Subject
TELEPHONE MICROPHONE POOR SOUND QUALITY FOR INCOMING CALLER

Model: X-TYPE

A419-16: This Technical Bulletin has been issued to address customer complaints that during a telephone conversation the incoming caller to the vehicle can hear a 'running water' sound.

Fig. 1

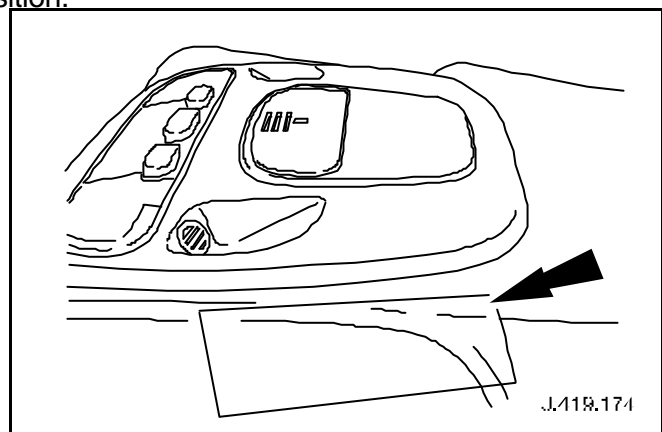
- 5 Move driver's side sun visor to a forward position.
- 6 Apply masking tape to driver's side of headlining (see Fig. 1).

Fig. 2

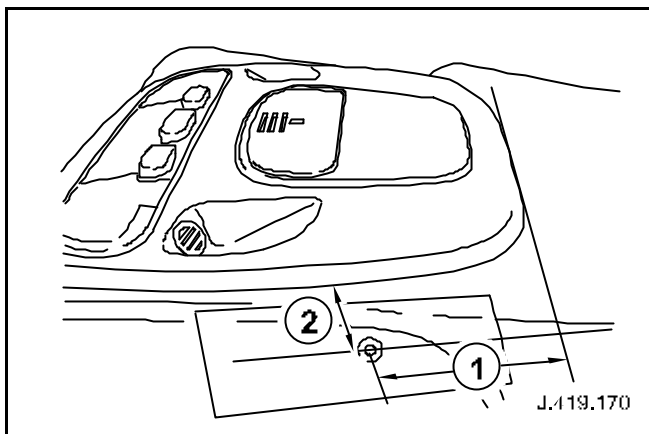
- 7 Measure and mark point 65mm forward of overhead console rear edge (see 1 Fig. 2) and measure and mark point 25mm from driver's side edge of overhead console (see 2 Fig. 2).

Fig. 3

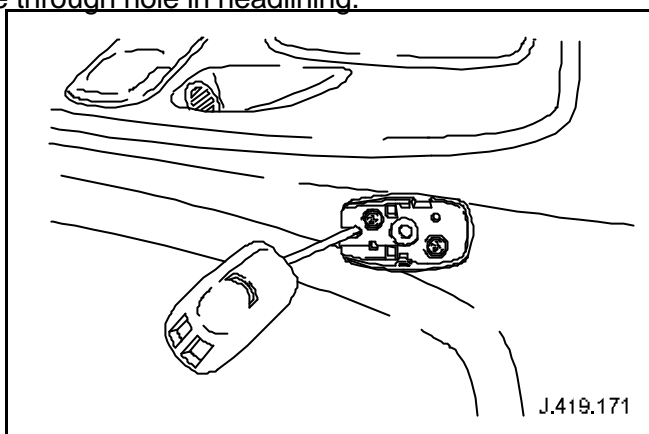
- 8 Remove overhead console (see Workshop Manual, JTIS CD ROM: section 501-12).
 9 Pierce hole (approximately 6mm diameter) at marked point through headlining.
 10 Remove masking tape.
 11 Feed electrical connector of new microphone through hole in headlining.
 12 Align new microphone base plate to headlining and install and tighten base plate securing screws (see Fig. 3).

Note: Ensure cable entry slot is facing forward and base plate is positioned to cover cable and hole in headlining.

Fig. 4

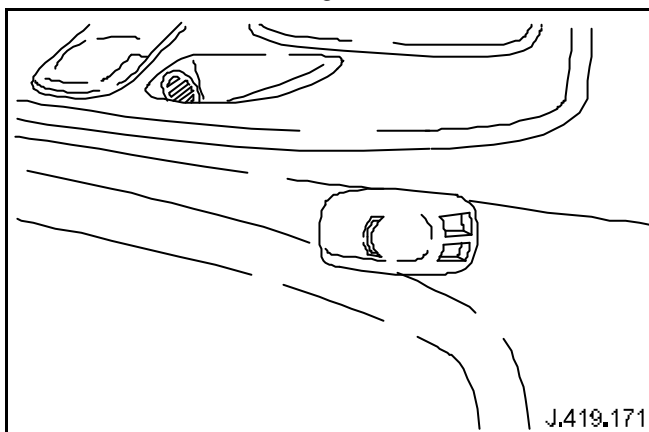
- 13 Clip new microphone to base plate (see Fig. 4).

Fig. 5

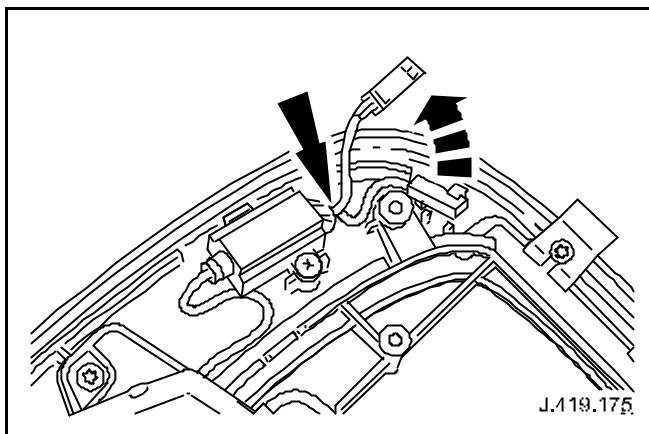
- 14 Cut, as close to filter as possible, and discard old microphone electrical connector and fly lead (see Fig. 5).
